Important Information — Dell OptiPlex 790/990

System Board

Heatsink Removal

Figure 2. System Board with the thermal sensor and heatsink removed

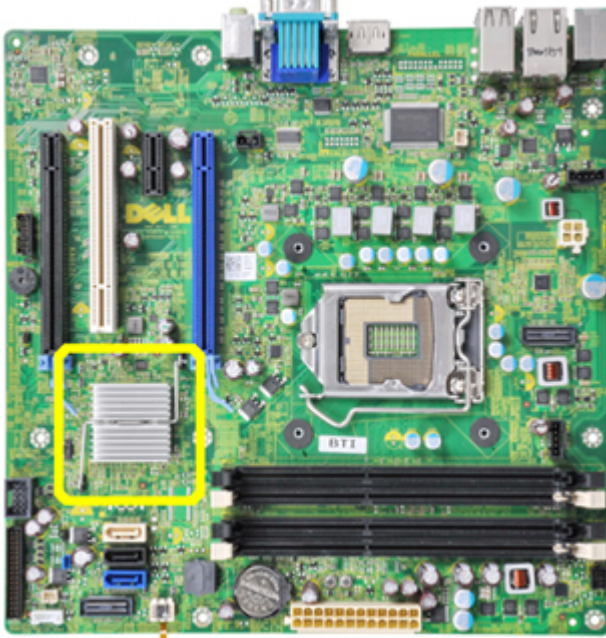
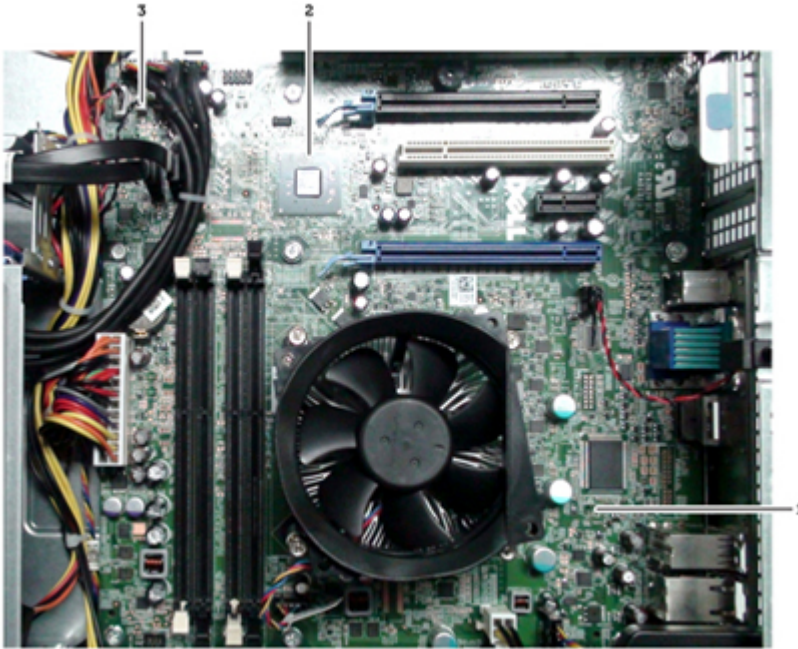
The Dell OptiPlex 790/ 790 computers are now shipped with a new system board without the following components:

1. Heatsink
2. Power supply thermal sensor (Desktop chassis only)

The following image displays an earlier version of the system board shipped with the heatsink.

All system boards shipped with the following BIOS versions or higher will NOT contain the heatsink.

The power supply thermal sensor is removed from the desktop chassis only.

1. thermal sensor connector-1 and cable removed
2. chipset heatsink removed
3. thermal sensor connector-2

If the BIOS is downgraded to an earlier version than the version listed above, an error message will be displayed.

NOTE: If you have replaced your system board with a new system board for the Desktop chassis, always ensure that the BIOS version is A11 or higher.

WARNING: If you do not update the BIOS, you may receive Alert! Chipset heat sink not detected error message during the power-on self test (POST).

NOTE: With the new system board, it is tested and found that all component temperatures are within the specifications.

NOTE: With the new system board, there is no impact on the system performance.
